DISABLE WINDSHIELD UPPER DEFROST GRID

Prevost vehicles

DESCRIPTION

On the vehicles affected by this bulletin, disable the windshield upper defrost grid by removing the electrical connections.

Figure 1

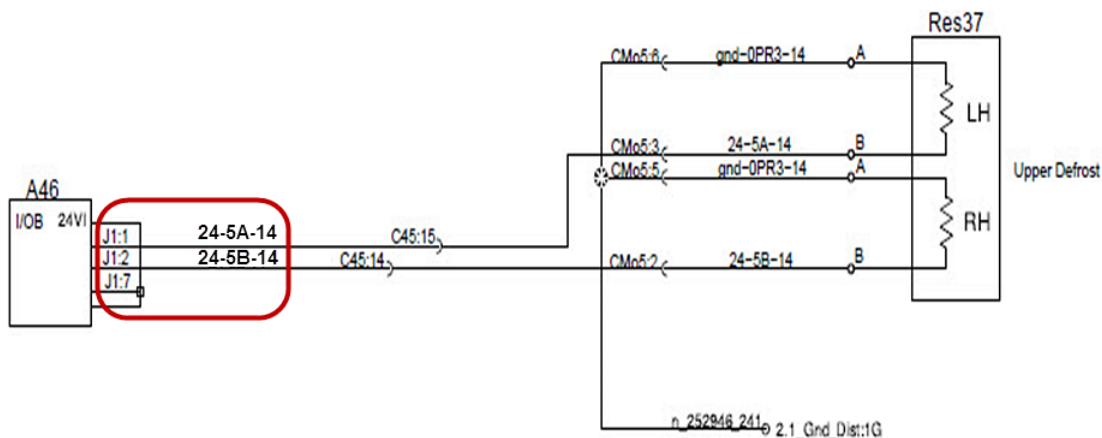
Disconnect wires **24-5A-14** and **24-5B-14** from Module **A46** to render the circuits completely inoperative.

Figure 2

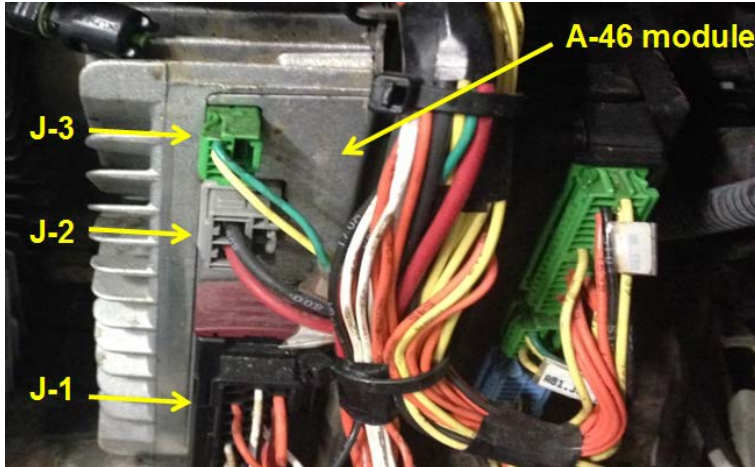
1. Locate module **A46** in the front electrical center and disconnect the J-3, J-2 & J-1 connectors in that order.

Figure 3

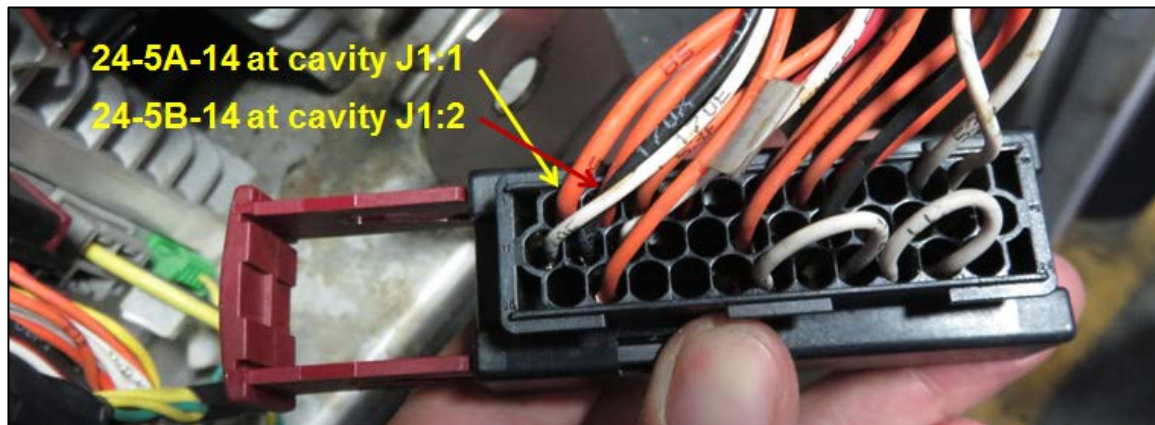
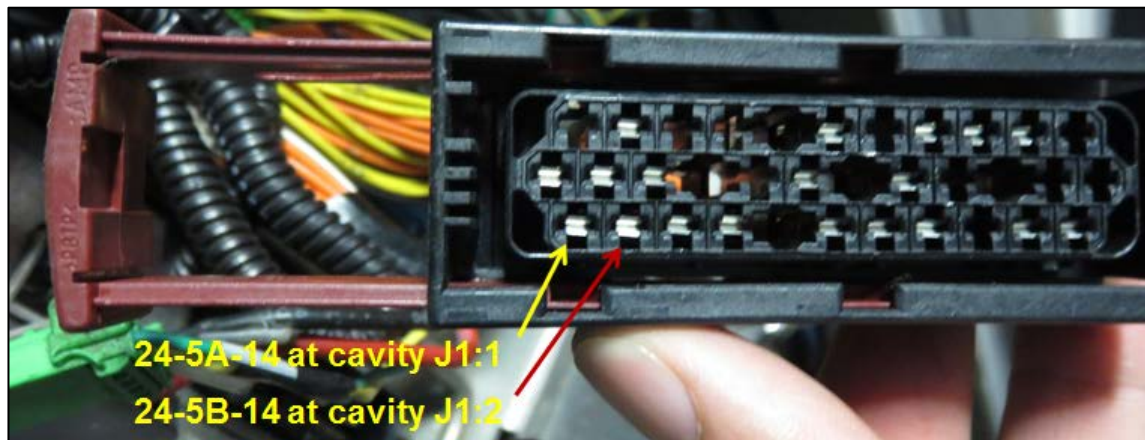
2. Locate wires 24-5A-14 and 24-5B-14 in connector J-1 for module A46.

Figure 5

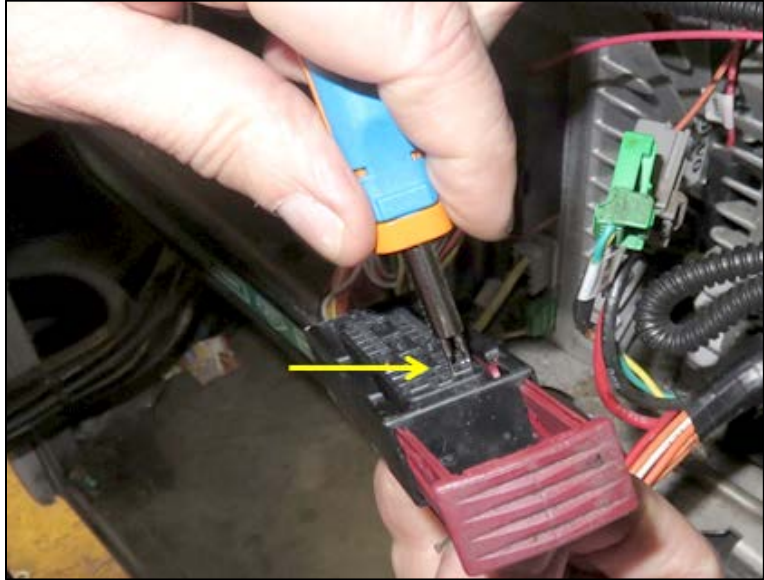
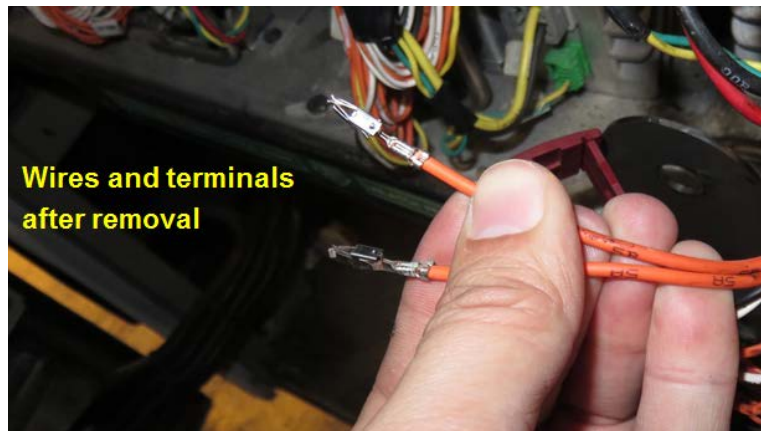
3. Use Tyco terminal extractor 683594 to remove wires **24-5A-14** and **24-5B-14** from their respective cavity locations in connector J-1.

Figure 8

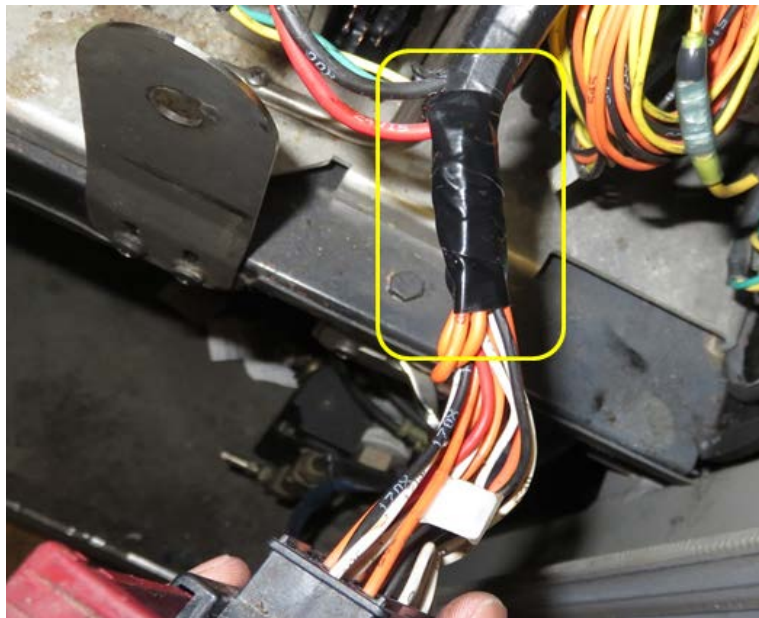
5. Tape the wire ends individually. Then tape both wires back to the harness with electrical tape.

Reconnect connectors J-1, J-2 and J-3 to module A46 in that order.
